UNITED STATES PATENT AND TRADEMARK OFFICE

APPLICATION NO.	FILING DATE	FIRST NAMED INVENTOR	ATTORNEY DOCKET NO.	CONFIRMATION NO.
09/822,575	03/30/2001	Naoki Nagasako	09792909-4797	7195

Office Action Summary

DETAILED ACTION

FIG.5

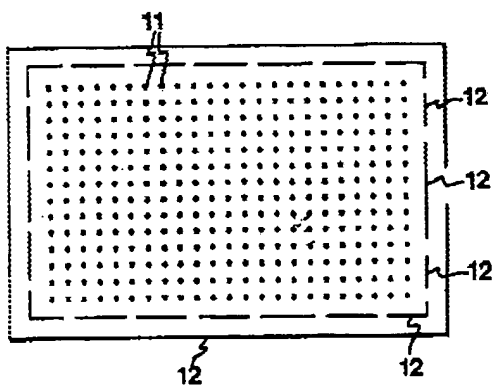
As to claim 1, Lagerwall discloses in Figures 5 and 3A a liquid crystal display apparatus comprising: a liquid crystal panel having a pair of substrates, 1 and 2, facing each other; and liquid crystal material (col. 9, lines 9-12) sealed between said pair of substrates, said pair of substrates being sealed at a first seal portion, 4, which is located at peripheral portion of said substrates and also being sealed at a linear-shaped spacer, 12, (Applicant's second seal portion) located outside of an effective picture element area separated from the peripheral portion and further wherein a supporting height of the first seal portion and the second seal portion is substantially the same, and the seal portions are adhered to the opposite substrate with a binder or any other type of joint (col. 11, lines 23-25 and col. 12, lines 22-25).

Lagerwall teaches dot-shaped spacers, 11, (Applicant's said second seal portion includes said dot-shaped seal portions) at neighbor of corners of said effective picture element area (four corners in figure 5) and further includes linear-shaped spacers, 12, (Applicant's linear-shaped second seal portions/part(s)) located and extending along an edge of the effective picture element area on all four sides (Applicant's opposite to said injection gate for liquid crystal material).
